Product/Process Change Notice - PCN 23_0281 Rev. -

PCN Title:	AD8417-2 WLCSP Data Sheet Revision
Publication Date:	10-Jan-2024
Effectivity Date:	10-Jan-2024 <i>(the earliest date that a customer could expect to receive changed material)</i>
Revision Description:	Initial Release.

AD8417-2 WLSCP

DATA SHEET REVISION

Figure 3. Pin Configuration

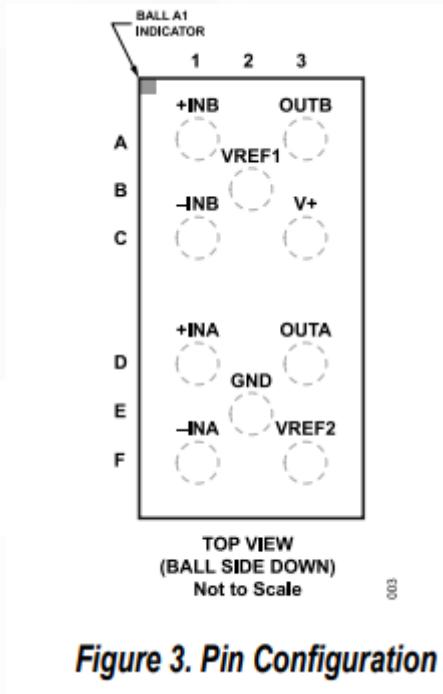
- 1) Update pin configuration figure and table to align with actual product pin configuration.

► FROM

Figure 3. Pin Configuration

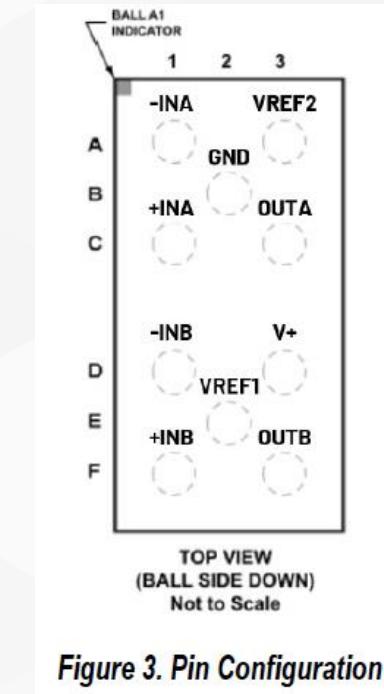
► TO
